Service Campaign 74-09

AFFECTED: 2025 Revels

SUBJECT: AC Sense Connection

B44E AC Sense Rework

Image 1

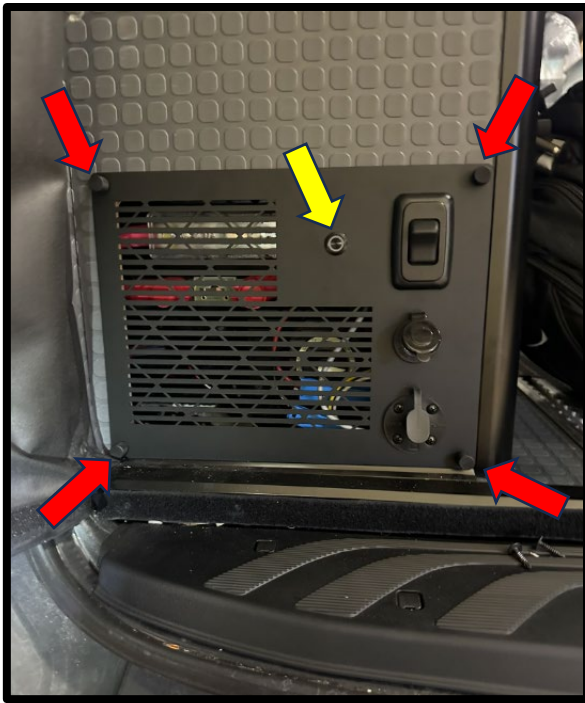
1. Locate the cover panel on the back of the battery cabinet, in the rear on the driver side. See Image 1.
2. Turn off the house battery by holding the remote on/off button for three seconds, see Image 1 yellow arrow. The LED around the button should not be lit.
3. Remove the 4 thumb screws and unmount the panel to gain access to the cabinet interior. See Image 1 red arrows and Image 2.

Image 3

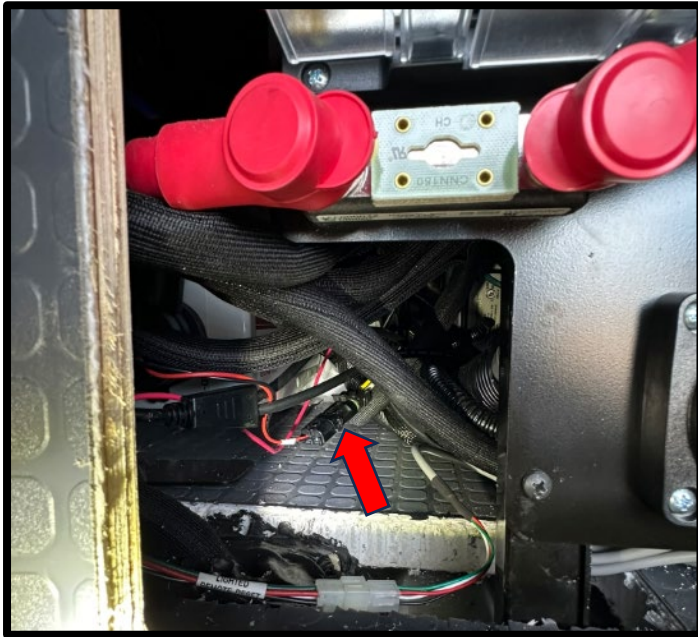
1. Locate the 2-pin Delphi terminal connection between the Lithionics BMS harness and the Winnebago Coach harness. See Image 3 red arrow.
 1. The BMS harness wires are 18 AWG black and red.
 2. The Coach harness is yellow and white 12 AWG wire. The part number printed on the harness is 000283434 and the circuits are WJ and 1JX.
2. Disconnect these terminals but leave them accessible in the cabinet. See Image 4.
3. Reinstall the cover panel.
4. The rework is complete.
